**REGULATION No. 16**  
**(Safety-belts)**

**Proposal for draft amendments**

**Proposal for draft Corrigendum 1 to Revision 5 to Regulation No. 16**

**Submitted by the expert from the European Association of Automotive Suppliers \*/**

Figure 1: Strap extraction when test acceleration has been reached after acceleration onset phase.

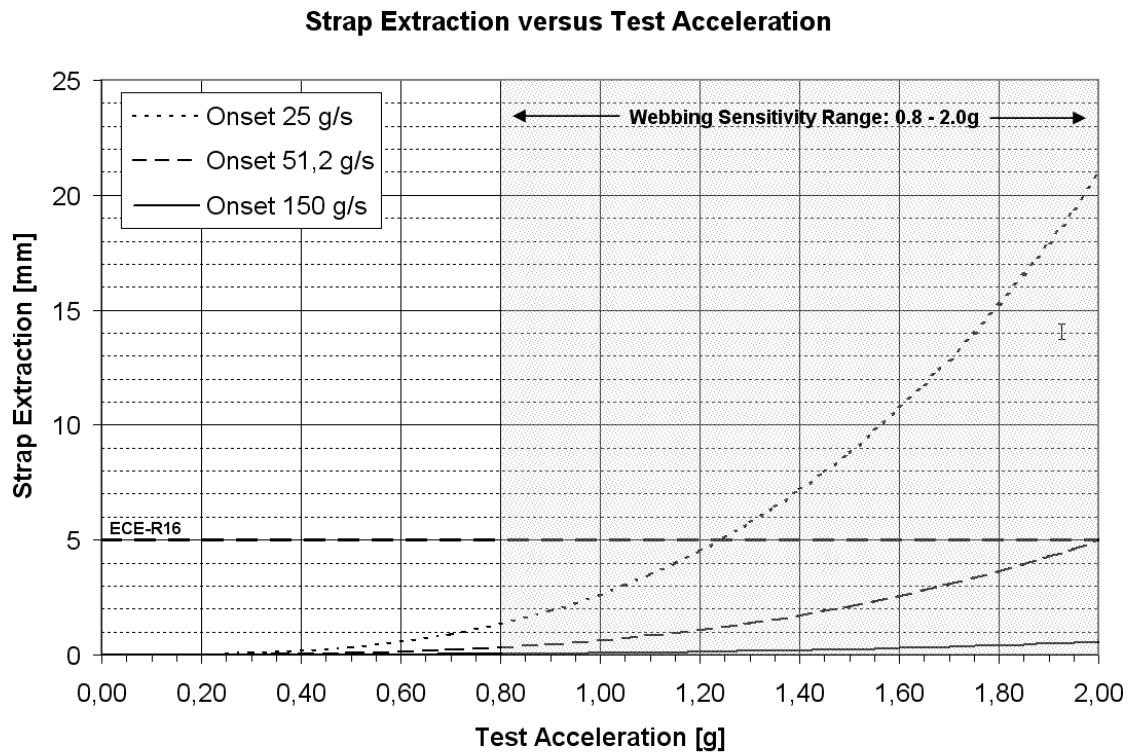
However, the two requirements cannot be considered independently from each other. An average onset rate (constant) leads to the following webbing extraction;

By applying the lower threshold of 25 g/s and a test acceleration of 2.0 g, which is the upper limit of the available locking range for webbing sensitive locking (0.8 – 2.0 g see paragraphs 6.2.5.3.1.2. and 6.2.5.3.2.), the resulting webbing extraction leads to  $s = 20,9$  mm and to a violation of the requested 5 mm.

In order to fully comply with the requested maximum 5 mm in testing the sensitivity for strap movement, the minimum average onset rate yields

For further clarification Figure 1 shows the resulting strap extraction as a function of the test acceleration for different onset rates.

The recommendation is to clarify paragraph 7.6.2.2. by differentiation into requirements for tests on the sensitivity for strap movement (upper limit 2.0 g) and for tests on sensitivity for vehicle deceleration (upper limit 0.45 g):

- (a) For the tests on the sensitivity on vehicle deceleration, a range of 25-150 g/s is still reasonable and a violation of the 5mm rule is not possible;
- (b) For the tests on the sensitivity tests on strap movement, an onset rate range of 55-150 g/s is recommended to avoid conflicts.
